BOARD OF COMMISSIONERS OF PUBLIC UTILITIES

**REVIEW OF TWO GENERATION
EXPANSION OPTIONS FOR THE
LEAST-COST SUPPLY OF POWER TO
ISLAND INTERCONNECTED CUSTOMERS
FOR THE PERIOD 2011 – 2067**

REPORT TO GOVERNMENT

MARCH 30, 2012

Preliminary HVdc Link Expansion Plan vs. Load Forecast

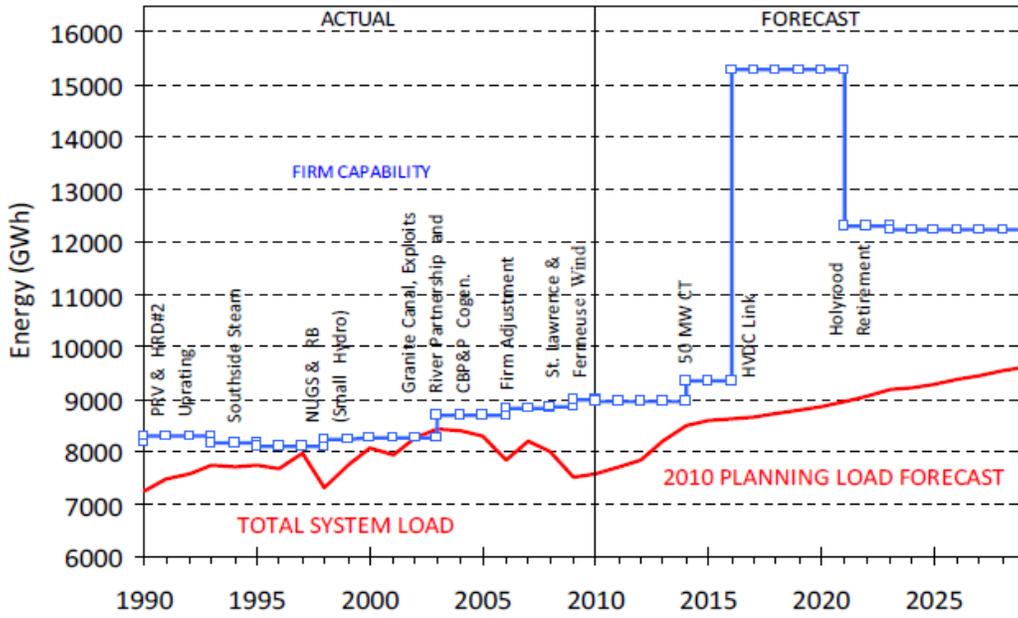
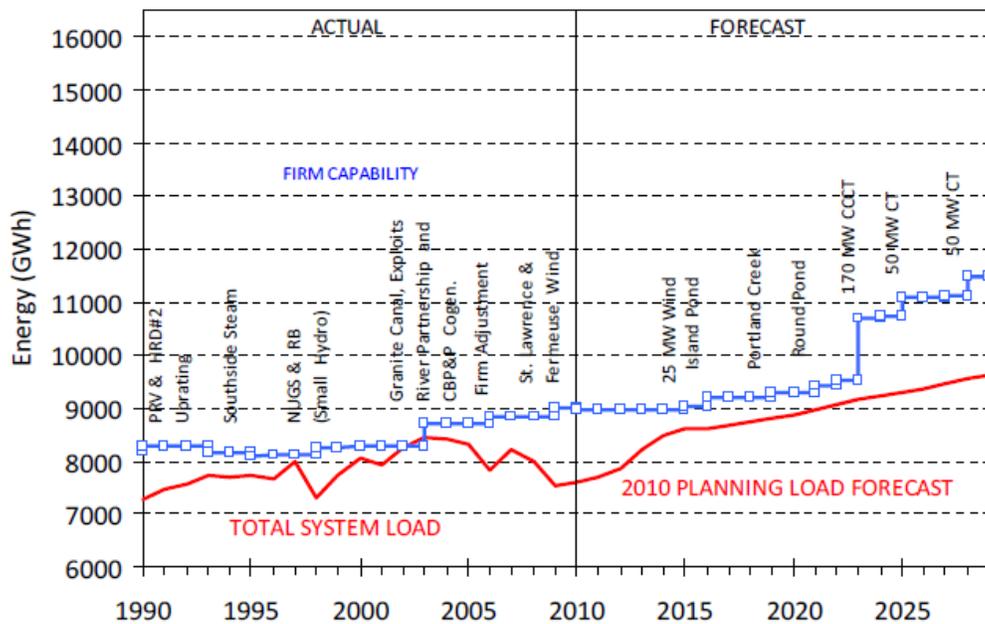
In relation to how the 2010 Planning Load Forecast relates to system capability, the Board refers to the comparison graphs of forecasted load and system capability set out above. The first graph shows the forecast energy shortfall in 2021. The next two graphs show how the two options will meet the forecast load. The Interconnected Option involves a very large incremental increase in generation capability and a significant amount of excess energy and capacity until well beyond the 20-year planning period. This graph highlights the significance of the assumption required by the Terms of Reference that the excess power is not monetized or utilized. As shown in the third graph the Isolated Island Option offers what might be considered a less risky approach more in line with principles of distributed generation, where capacity and energy are added in smaller increments more closely matching the load forecast.

These graphs show that there is not an immediate need for the large incremental supply associated with the Interconnected Option and that Island electricity needs could be met in the short to medium term with available renewable sources on the Island and/or additional thermal generation. It appears that avoidance of fuel costs is a critical factor in this generation planning decision. Nalcor's analysis shows that the Interconnected Option is least-cost primarily as a result of the avoided fuel costs associated with the closure of the Holyrood Thermal Generating Station.
